SITE PLAN (AREA OF DEVELOPMENT)
SCALE: 1" = 20'-0"

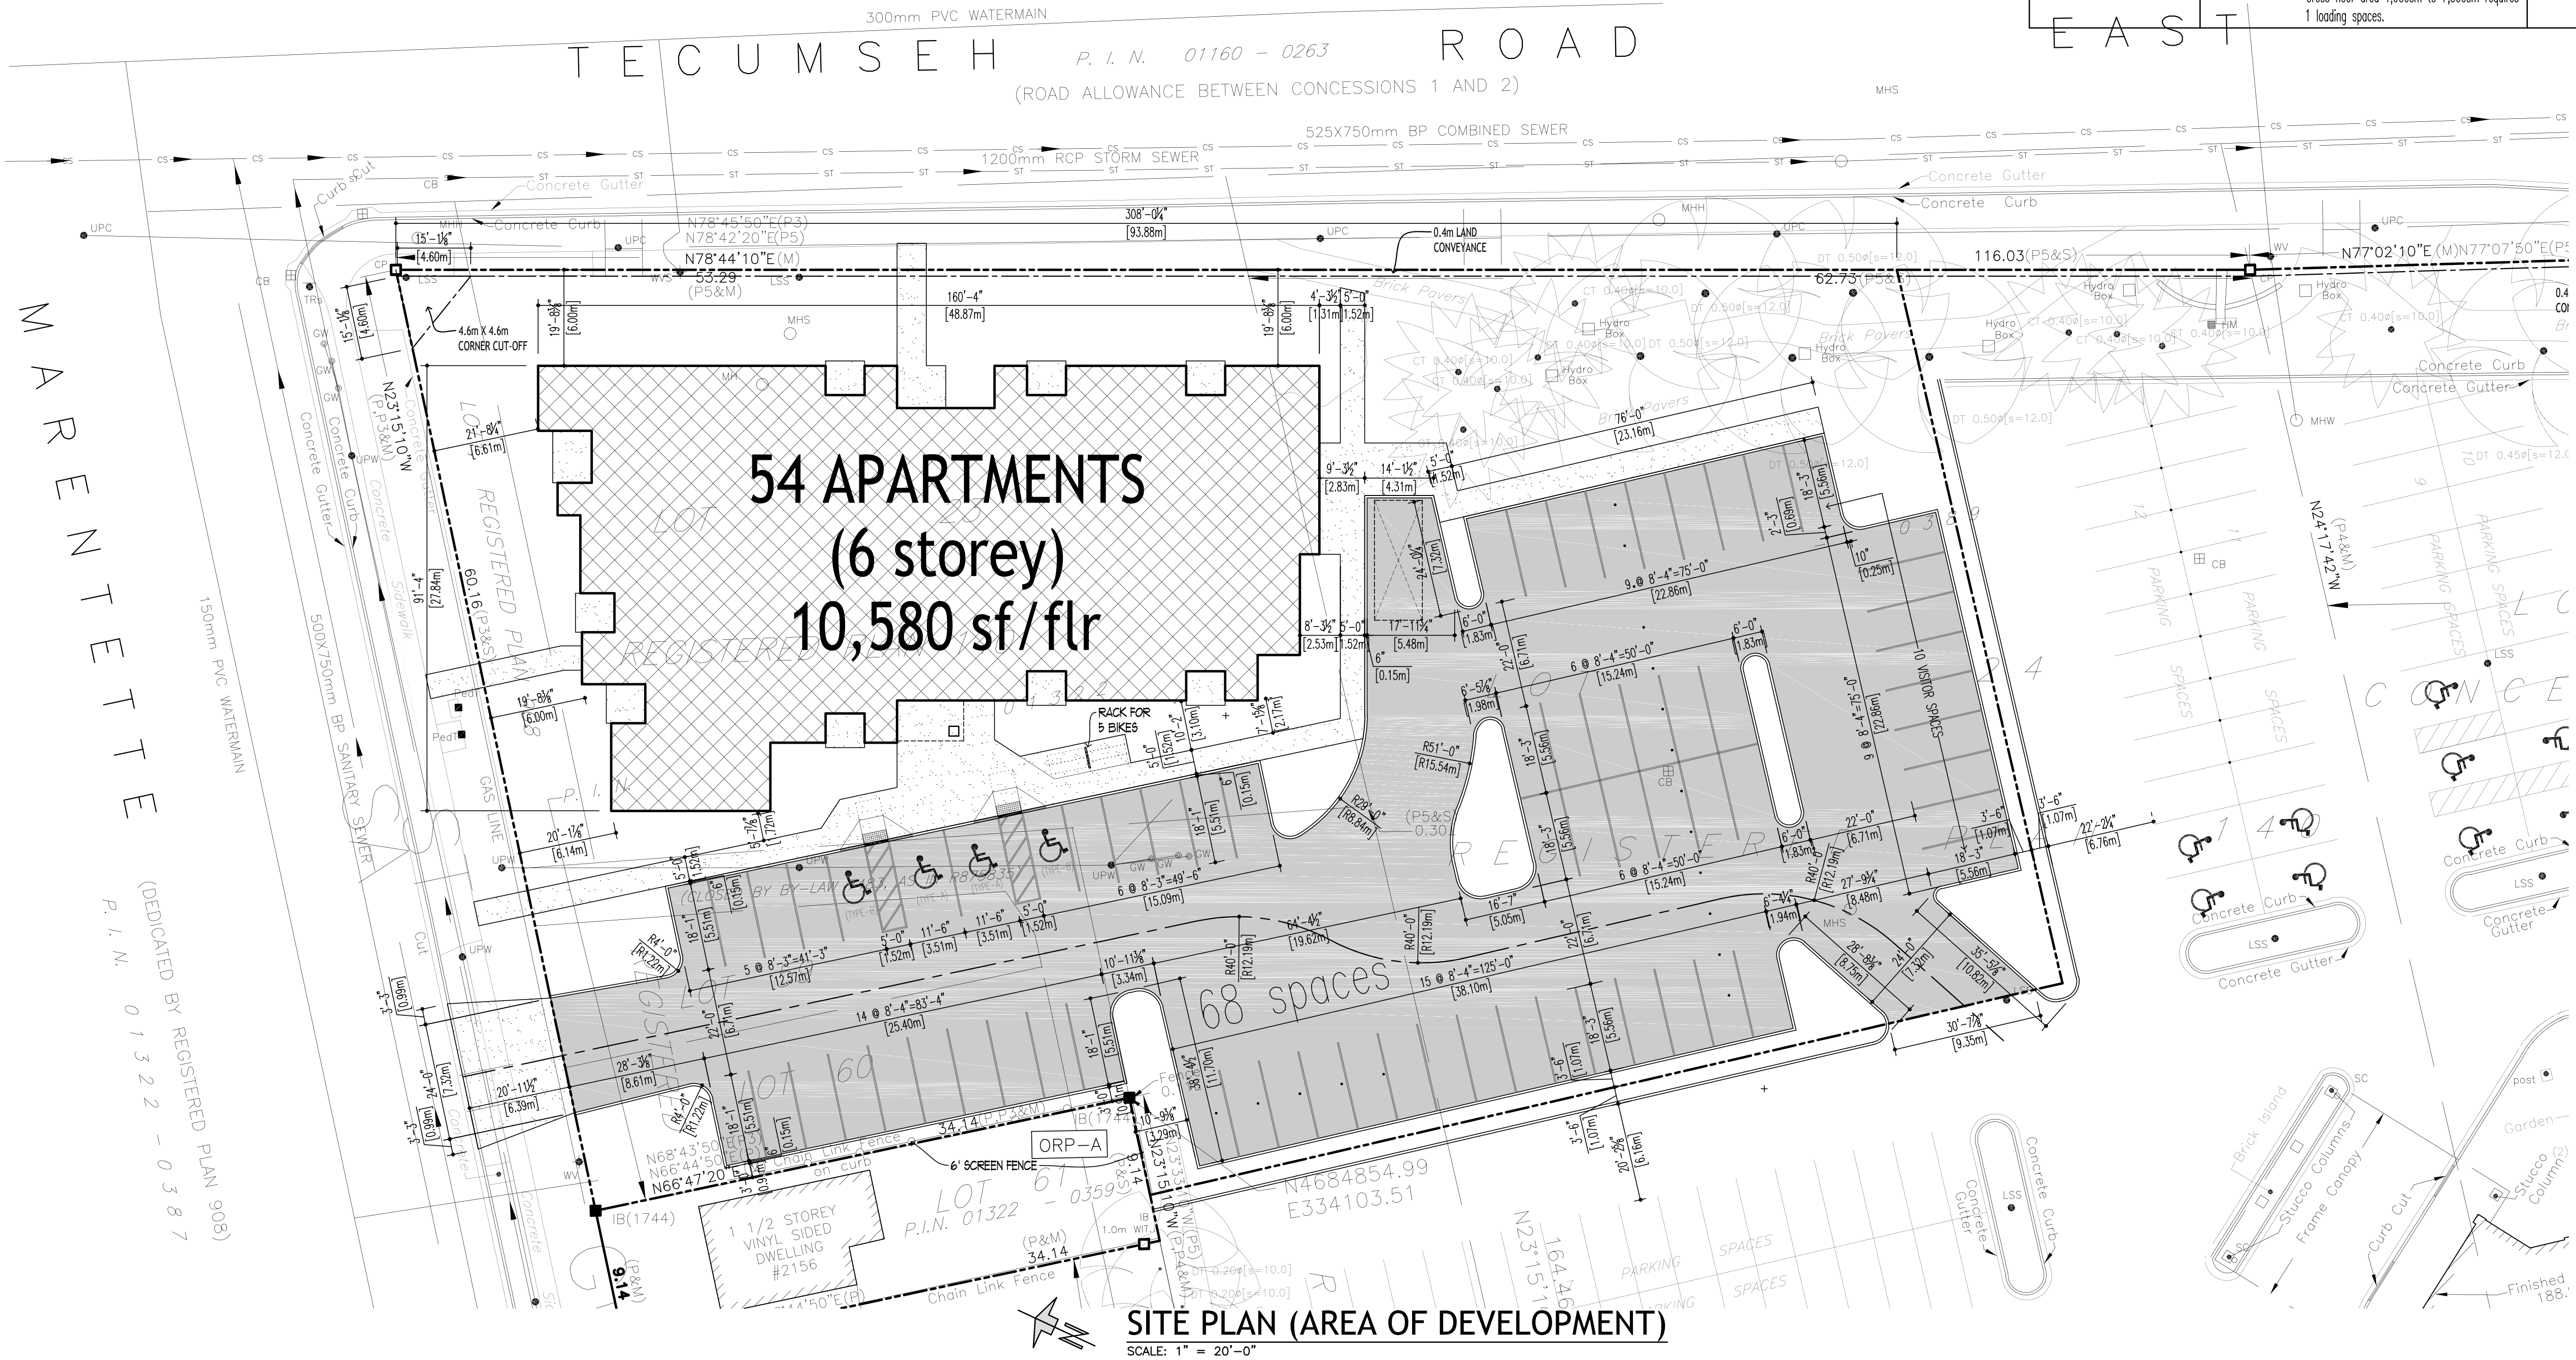
The latest concept site plan provided includes a new connection between the Caboto Club parking lot and the subject development, which was not included in previous submissions. The review and approval of this new parking lot connection will be addressed through Site Plan Control, subject to the submission of a Transportation Impact Study (TIS), satisfactory to Transportation Planning.
